Proposed Development – 2 to 6 Conway Avenue, 15 & 15A Fernleigh Avenue, & 38 to 40 Carlisle Street, Rose Bay

Preliminary Assessment of Potential Geotechnical Impacts on Neighbouring Properties

Our ref: JM/C17267_Rev1

Reference/ Revision	Description	Date	Author	Reviewer
JM/C17267 Rev1	For comment – Geotechnical Assessment	25/02/2026	JM	MD

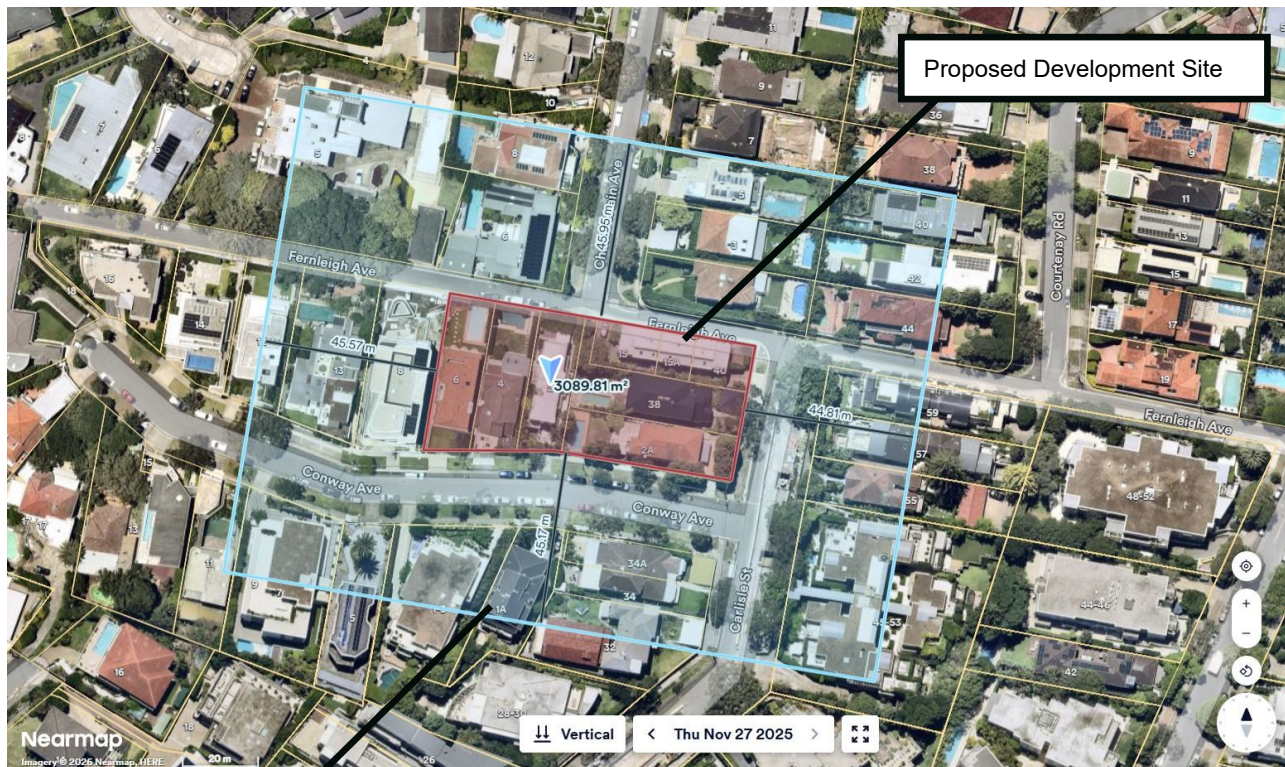
A Dewatering Management Plan has not been provided, nor any results of numerical modelling to determine groundwater inflow rates, groundwater drawdown, and settlement due to groundwater drawdown, due to temporary dewatering on this project. Therefore, **it is our assessment that a detailed dewatering management plan, including dewatering methodology (and the effectiveness of any proposed method), modelling and analysis of groundwater drawdown, and impact of groundwater drawdown must be provided by the proponent prior to granting any approvals.** However, based on past experience with similar nearby projects, are comments our below:

- Based on an estimated hydraulic conductivity of between 1×10^{-5} and 6×10^{-6} m/s, the basement excavation extending 5m below the groundwater level, and a four-month dewatering period, we estimate a Short Term Flows for Temporary Dewatering During Construction of well above the WaterNSW threshold of 3ML/year for an exemption from the requirement of a Water Access Licence. Therefore, a Water Access Licence is expected to be required for the development.

Plate 4-2: Graphical Representation of the Depth of Expected Groundwater Drawdown at Distances Extending From the Excavation Boundary (not based on numerical modelling, as this has not been provided by the proponent)

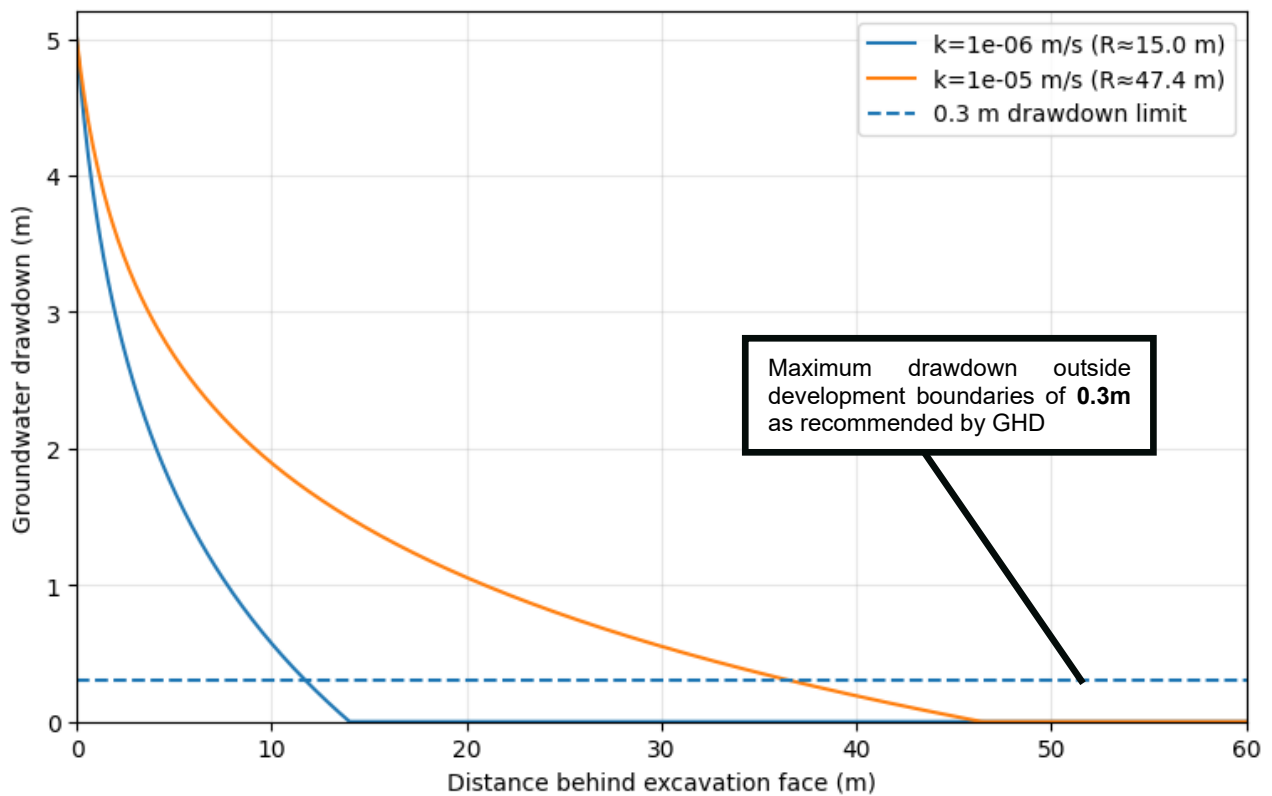
- There are existing structures within 5m to 10m of the proposed excavation, and our estimate is that drawdown of the water table could be greater than 2m depth at this set back distance. The GHD report commissioned by Woollahra Municipal Council states that such drawdown can cause settlement and damage to properties, and therefore recommended that **a limit of 0.3m of groundwater drawdown outside the development boundary** be permissible. Given that we estimate that groundwater drawdown will be greater than this affecting between 20 and 25 neighbouring properties, it is assessed that the proposed development would not comply with Council advice under these conditions.

- Plate 4-2 below is a graph prepared by us based on our own assessment showing the potential groundwater drawdown at set-back distances behind the excavation shoring wall. It should be noted that this is our preliminary estimate, as no numerical modelling has been provided by the proponent.

Plate 5-1 – Indicative markup provided by the client showing the development site (yellow), proposed LMR development sites (red), and known properties that have experience structural damage due to adjacent developments.

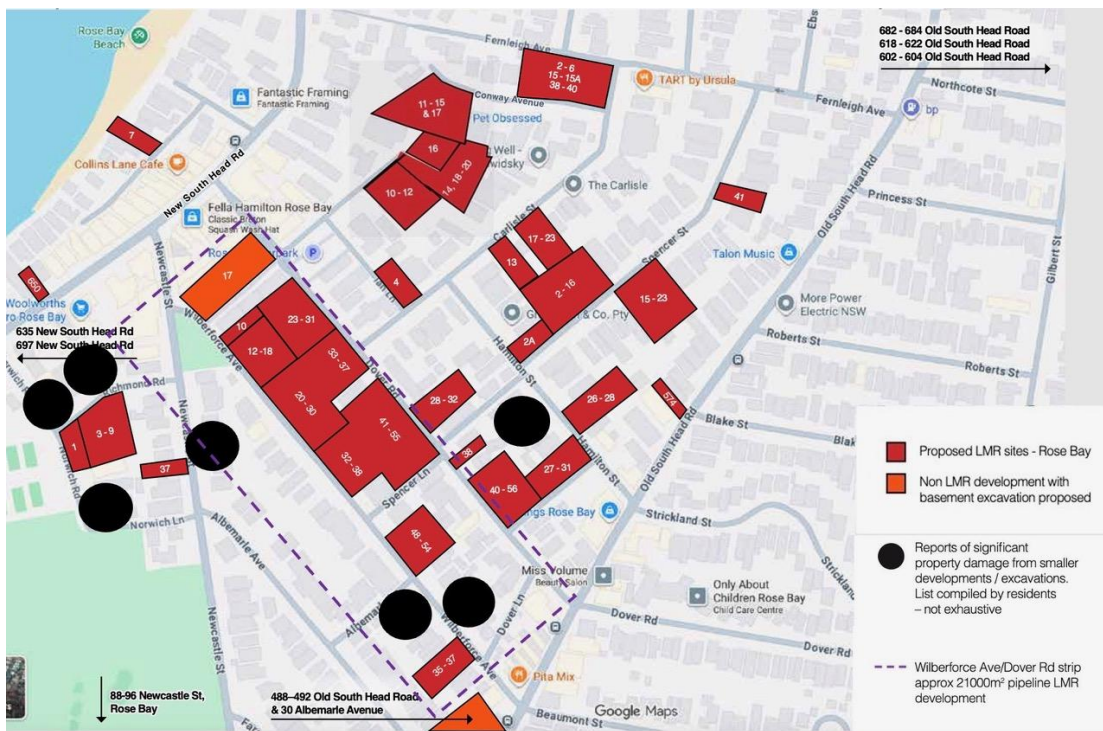
- Numerous instances in Double Bay and Rose Bay of structural cracking and damage to existing houses and apartments which are located near or adjacent to building sites where deep excavations with dewatering are being undertaken. Specific instances where structural damage to neighbouring properties that have been attributed to shoring installation (both from vibrations due to installation of sheet piling and over-flighting for bored piles), excavation and dewatering works in Rose Bay are shown in Plate 5-1 and include:

- o Norwich Lane – back wall came away from the neighbouring house
 - o Richmond Avenue – structural cracks appeared in block of neighbouring units (stop work issued).

- o Wilberforce Avenue – neighbouring house collapsed. The house was deemed unsafe for occupancy and it was subsequently sold and demolished.
 - o Wilberforce Avenue – the same above development caused flooding into the basement of a neighbouring house.

- o O'Sullivan Road – sink holes appeared in the road
